# NEWMAR CORPORATION WARRANTY DEPARTMENT

TECHNICAL SERVICE BULLETIN																			
DATE ISSUED		MODEL YEAR(S) AFFECTED		MODEL(S) AFFECTED		TSB #													
3/17/08		2008		"All Electric" EXDP		332													
BRAND						TYPE													
All	<input type="checkbox"/>	American Star	<input type="checkbox"/>	Mountain Aire	<input type="checkbox"/>	All	<input type="checkbox"/>	T T	<input type="checkbox"/>										
Cypress	<input type="checkbox"/>	Dutch Star	<input type="checkbox"/>	Kountry Aire	<input type="checkbox"/>	F W	<input type="checkbox"/>	C A	<input type="checkbox"/>										
Northern Star	<input type="checkbox"/>	Kountry Star	<input type="checkbox"/>	Essex	<input checked="" type="checkbox"/>	D P	<input checked="" type="checkbox"/>	D B	<input type="checkbox"/>										
Scottsdale	<input type="checkbox"/>	King Aire	<input type="checkbox"/>	London Aire	<input type="checkbox"/>														
All Star ME	<input type="checkbox"/>	Ventana	<input type="checkbox"/>

## TSB 332 Wire Procedure

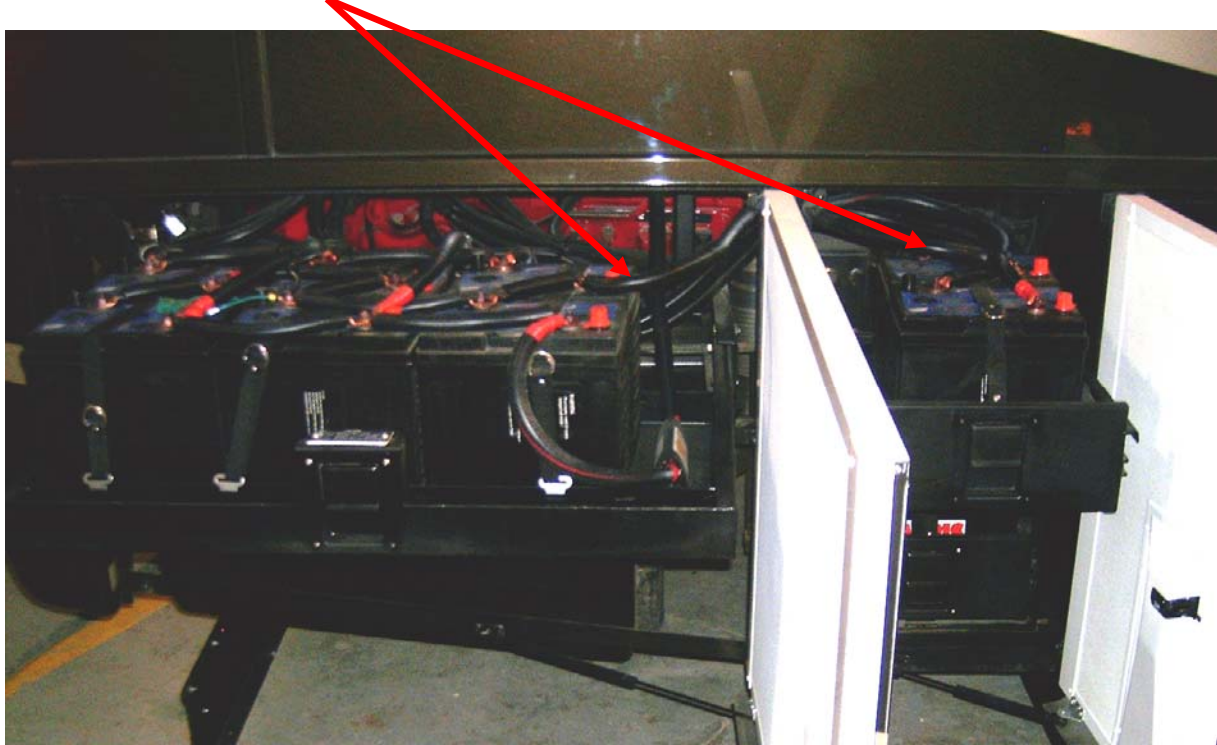
On a 2008 "All Electric" Essex, open both battery compartments and extend the trays completely for inspection. Confirm the cable linking the 6VDC side of the two battery banks together was installed.

The cable in question is installed between the right rear battery in the main bank and the rear battery in the second bank of batteries. Secure it with tie straps so it does not drop onto exhaust components.

If this cable is missing, install the following:

- 1) Approximately 4' of 3/0 cable (Newmar part # 51829)
- 2) Approximately 4' of black conduit to cover the cable (Newmar part # 35270)
- 3) 2 – Crimp on terminal end rings (Newmar part # 22404)
